January 11, 1984

INFORMATION CONSIDERED NECESSARY REGARDING EXPLORATORY SHAFT CONSTRUCTION AND SEALING

**RESPONSE TO NRC LETTER OF JUNE 15, 1983 ON THE SUBJECT OF
EXPLORATORY SHAFT CONSTRUCTION AND SEALING**

Figure 1. Schematic Diagram of Shaft Operational Seals Showing Chemical Seal Ring (CSR)

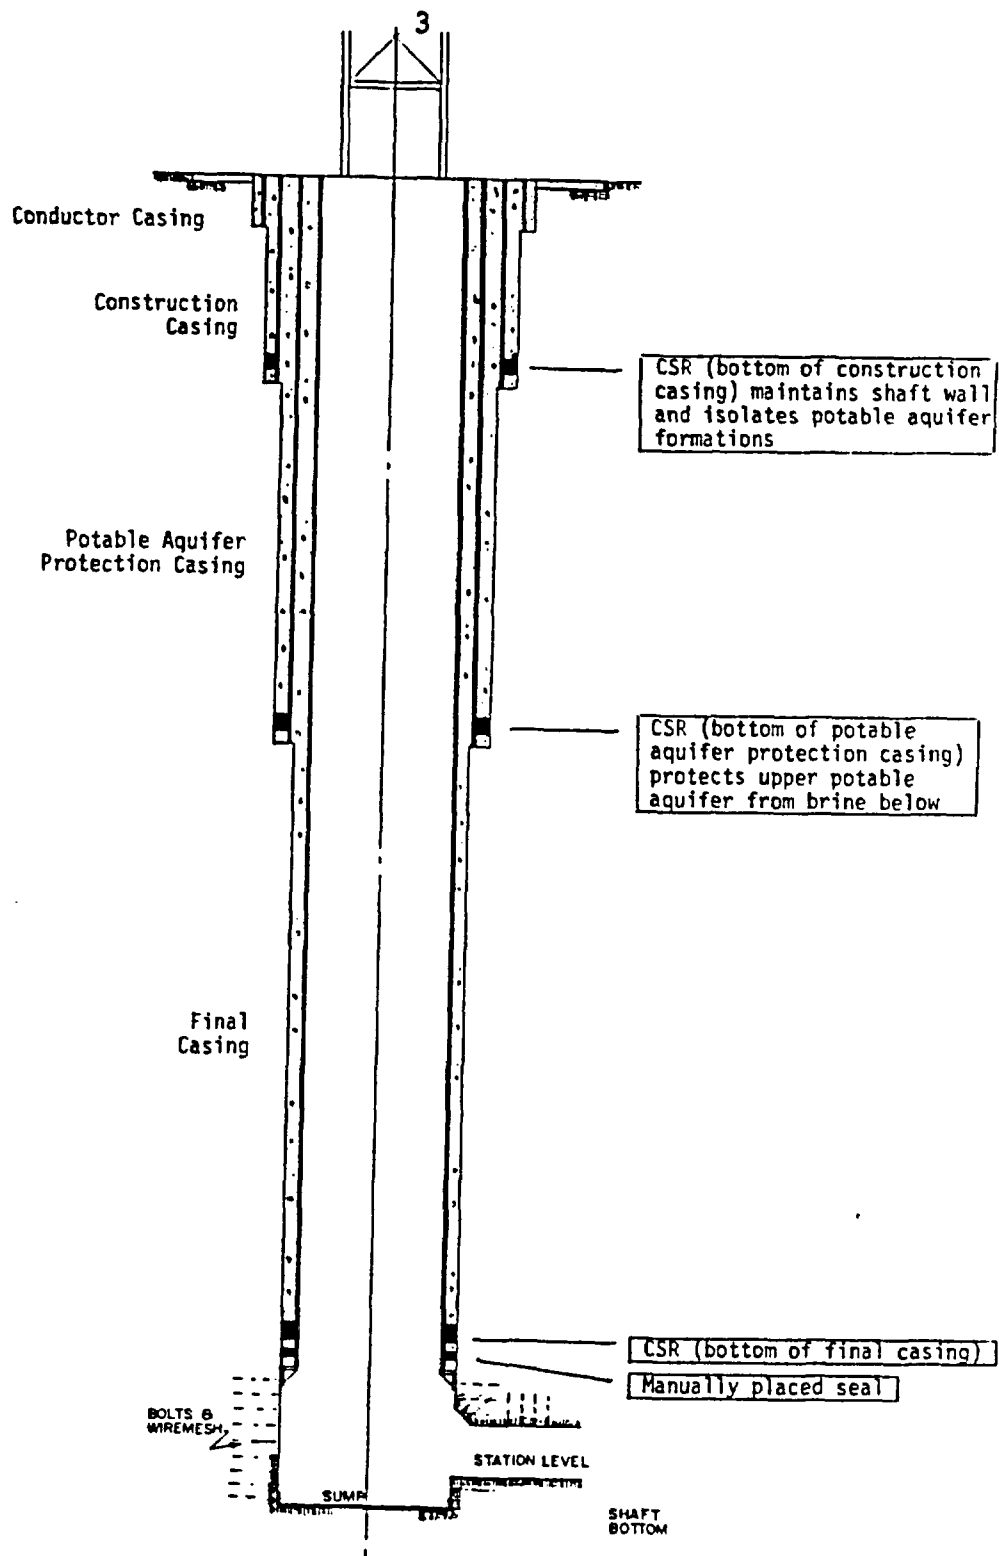
- C. Provide design specifications for the shaft construction and show how they deal with factors affecting sealing.**

The ES design specifications dealing with factors affecting sealing concern the short-term operational seals. For example, the design for the Permian Basin shaft calls for remotely placed chemical seal rings and oil field type grout seals, and a final manually placed operational seal. Figure 1 shows the location of the oil-field type grout seals and chemical seal rings (Reference 1). The details for the manually placed seal are shown in Figure 2 (Reference 1).

Multiple liners have been designed for various proposed sites. In the Permian Basin, for example, four sets of liner casing (Figure 1) are required to support the shaft walls and prevent ground water migration (References 1, 2).

Figure 3. Schematic Diagram of Shaft Decommissioning Seals

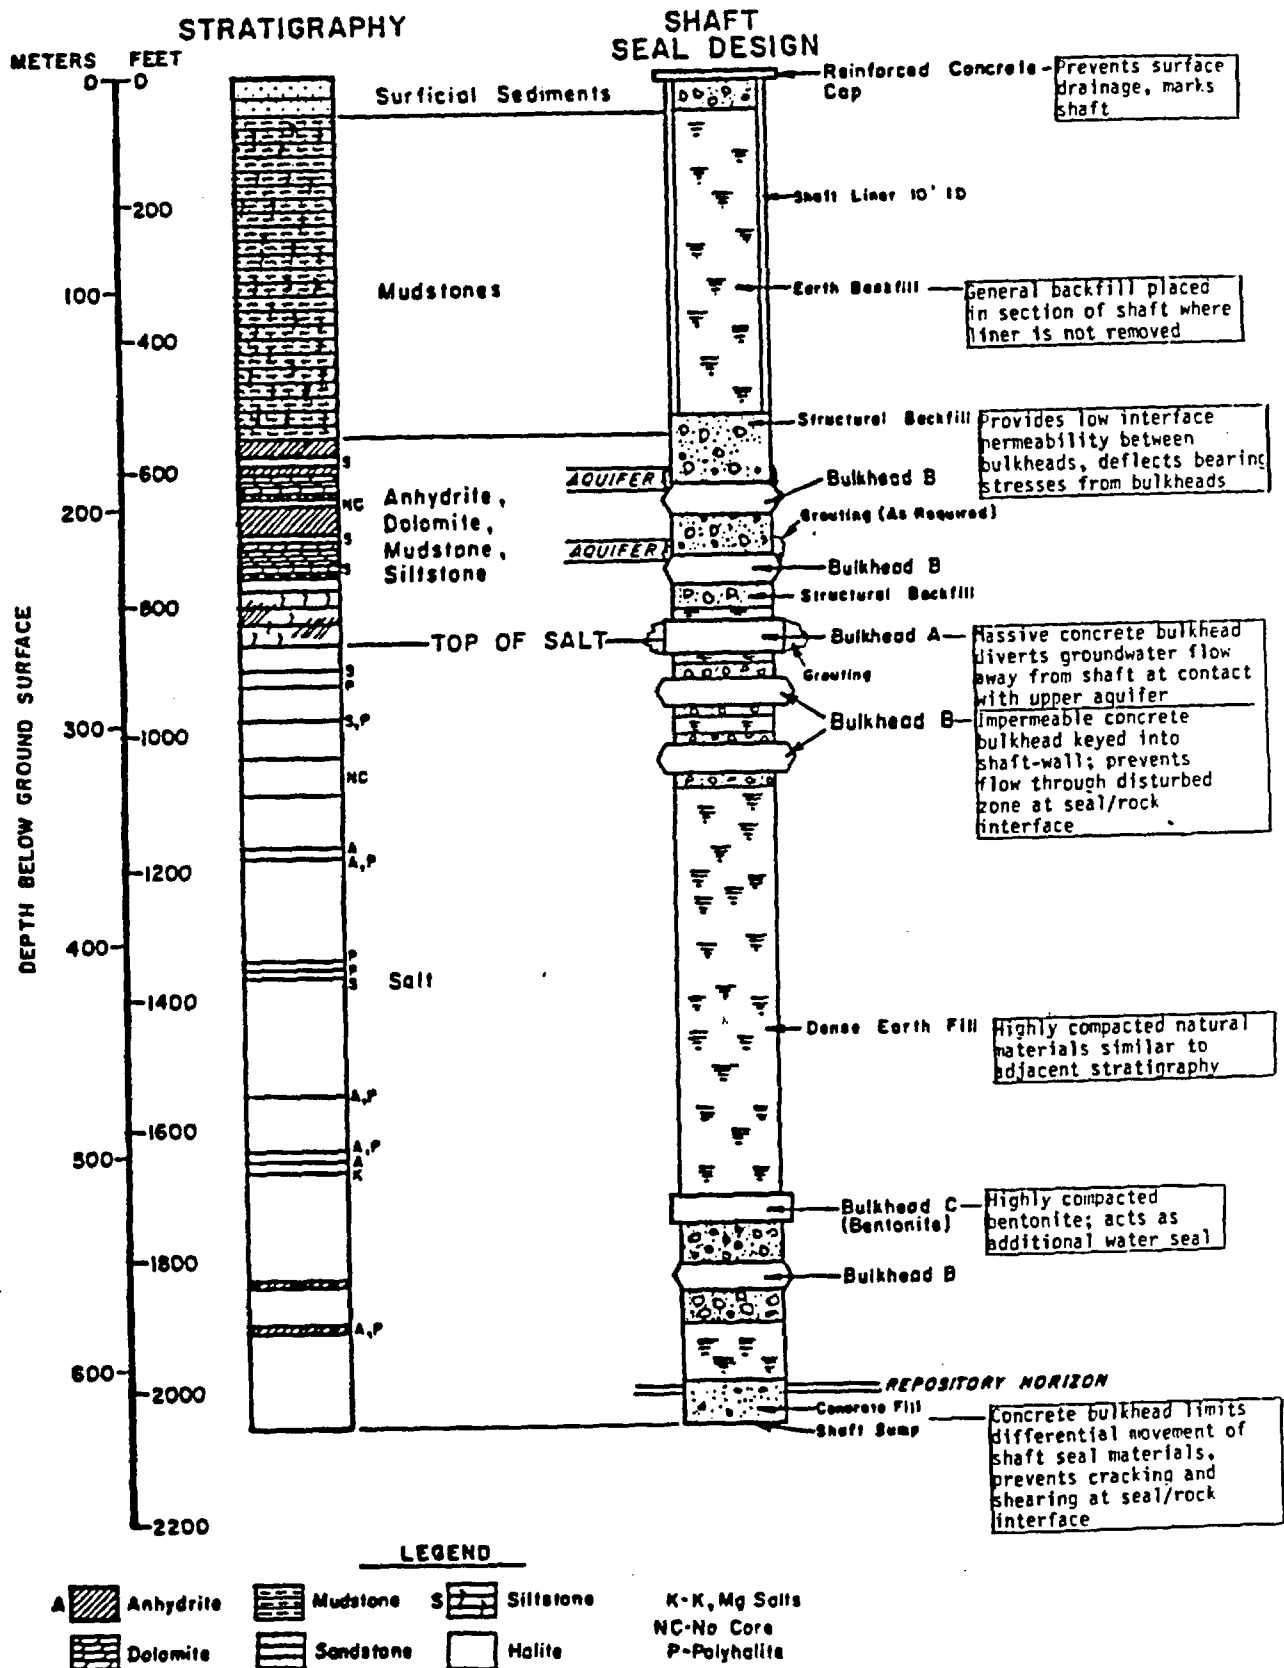
D. Describe the seal design and materials.

The long term decommissioning shaft seals include multiple components (References 7, 10). As shown in Figures 3 and 4, there are: three types of "bulkhead seals"; three types of backfill material between the bulkhead seals; and top and bottom structures. The bulkheads constructed of concrete will use mix designs based on PSU and WES formulations developed for borehole sealing (Reference 11). Aggregates used in the concrete will be compatible with the adjacent stratigraphy.
